UNITED STATES
NUCLEAR REGULATORY COMMISSION
WASHINGTON, D. C. 20555

SUBJECT: USE OF WESTINGHOUSE OPTIMIZED FUEL ASSEMBLY (OFA) AS RELOAD FUEL

Re: R. E. Ginna Nuclear Power Plant

SAFETY EVALUATION BY THE OFFICE OF NUCLEAR REACTOR REGULATION
SUPPORTING AMENDMENT NO. 61 TO PROVISIONAL OPERATING LICENSE NO. DPR-18
ROCHESTER GAS AND ELECTRIC CORPORATION
R. E. GINNA NUCLEAR POWER PLANT
DOCKET NO. 50-244

FIGURE 2.1-1
CORE DNB SAFETY LIMITS
2 LOOP OPERATION

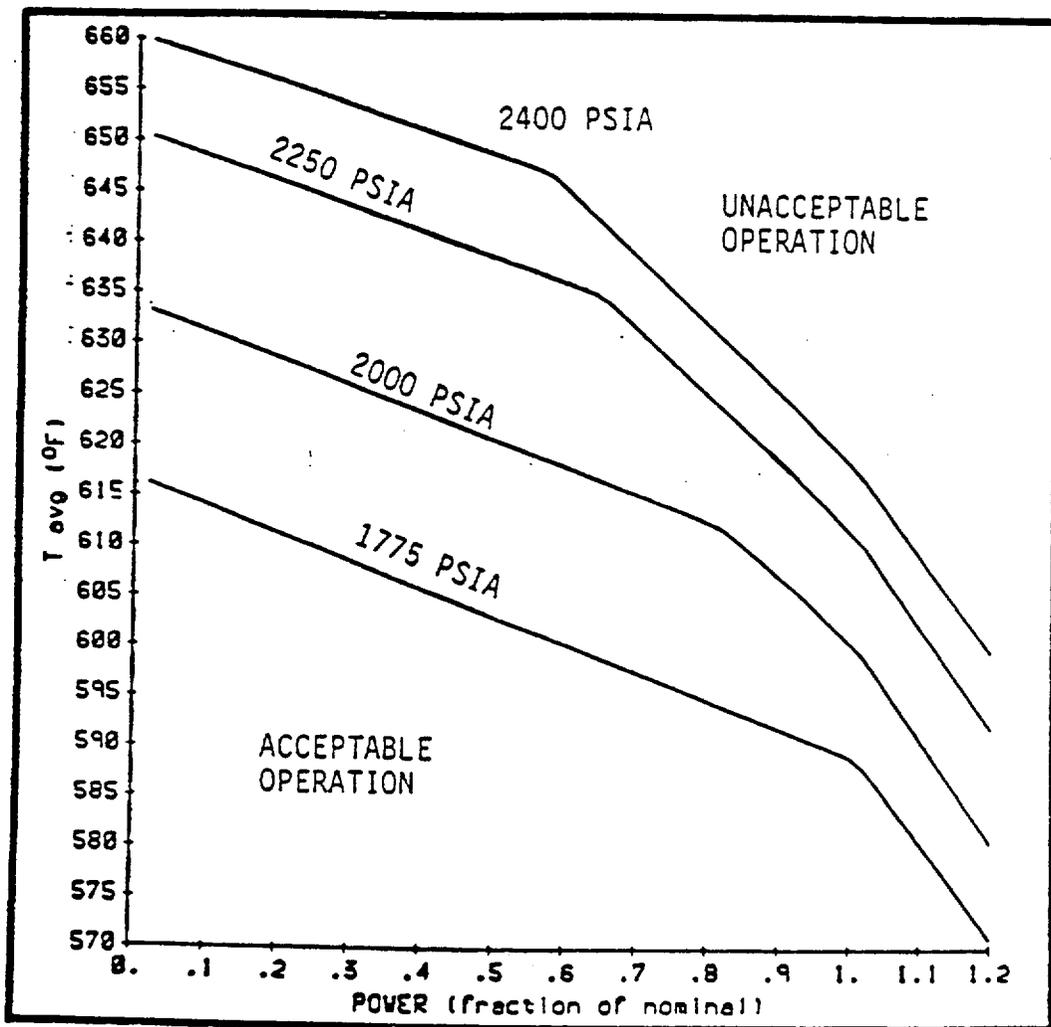
6.3 Figure 2.1-1 - Core DNB Safety Limits

This figure has been modified to account for the ITDP. For the mixed core of ENC and W OFA fuel, the setpoints for accident analysis are based on the W-3 correlation with DNBR limit of 1.30 for the ENC fuel as this is the most limiting. This is acceptable.

FIGURE 3.10-3

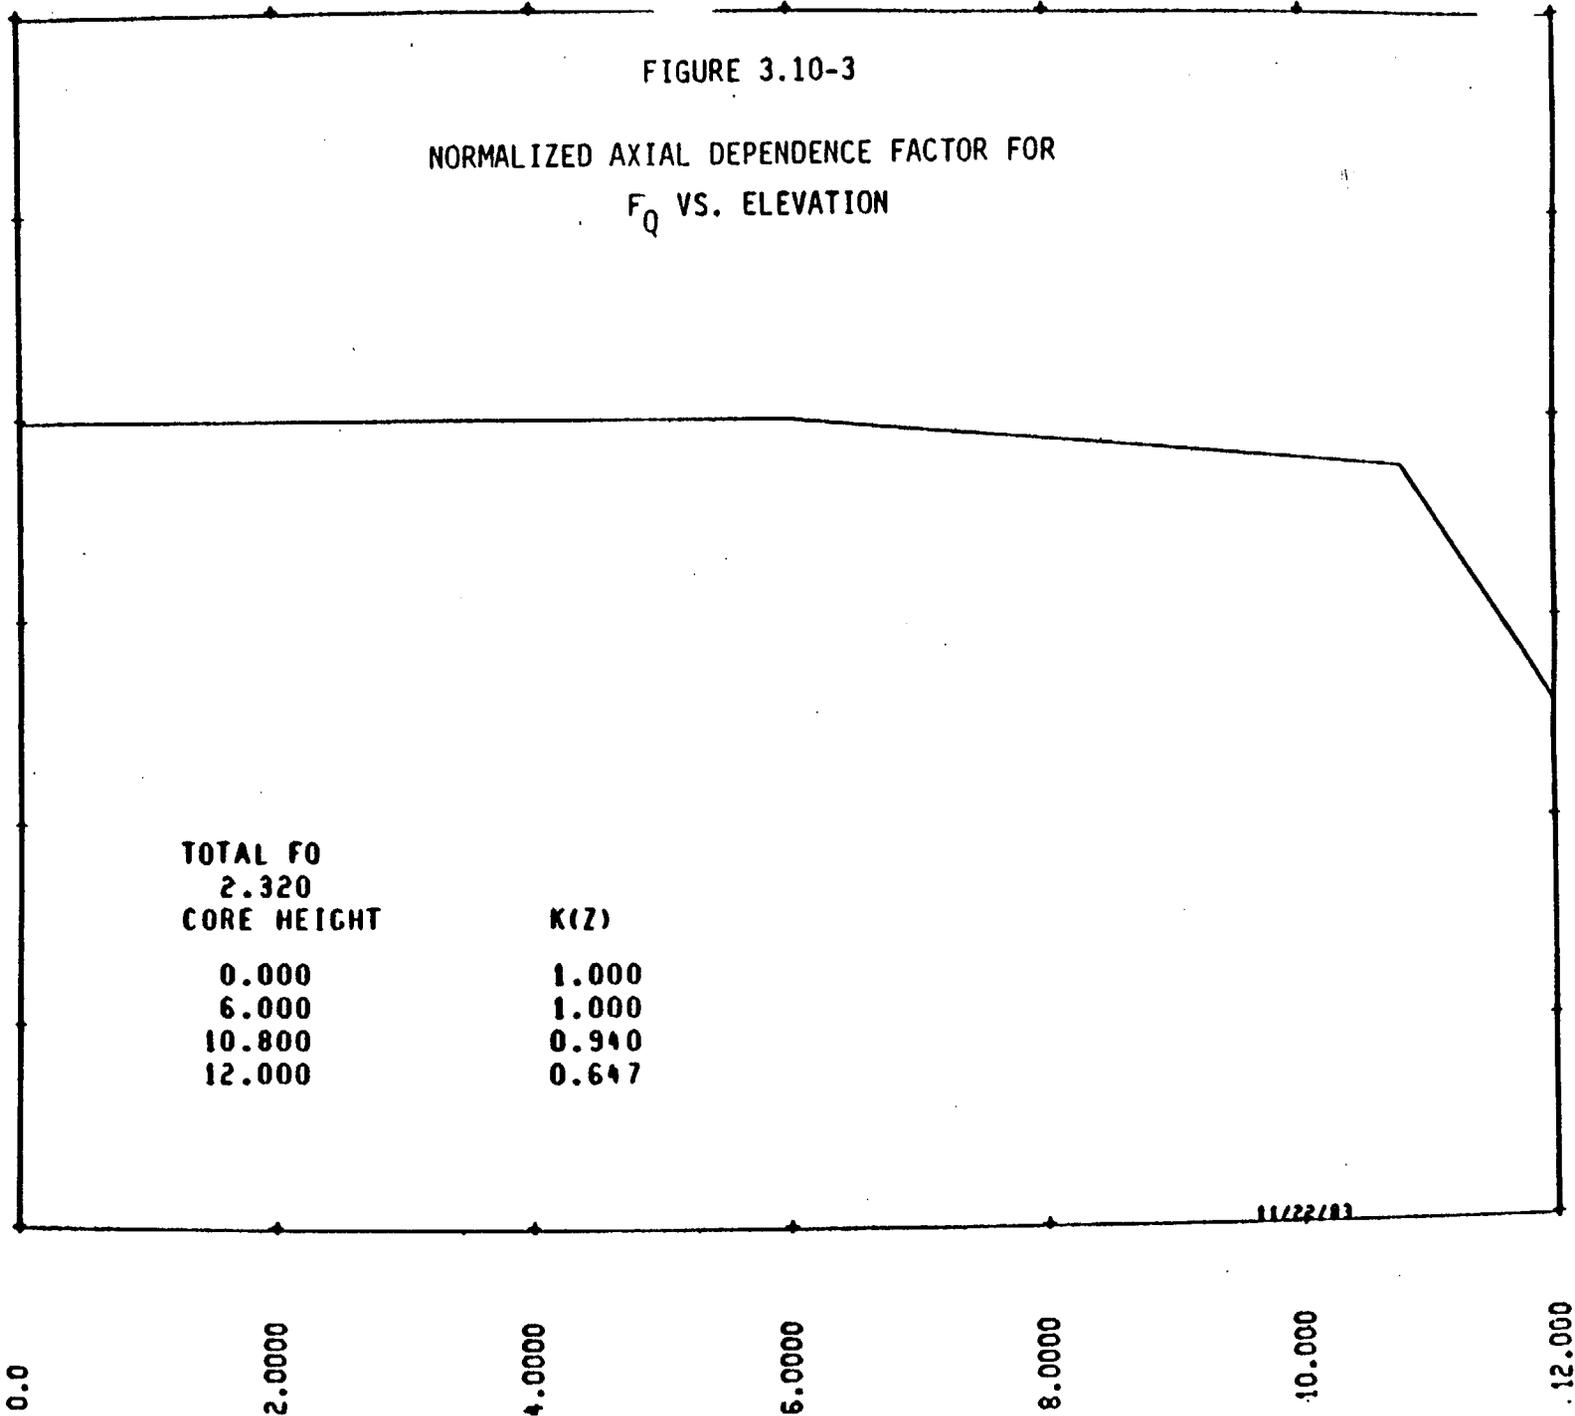
6.11 Figure 3.10-3 Normalized Axial Dependence Factor For F_q vs Elevation

This proposed figure is very close to the previous values and represents changes for the mixed core using ITDP. We find it acceptable.
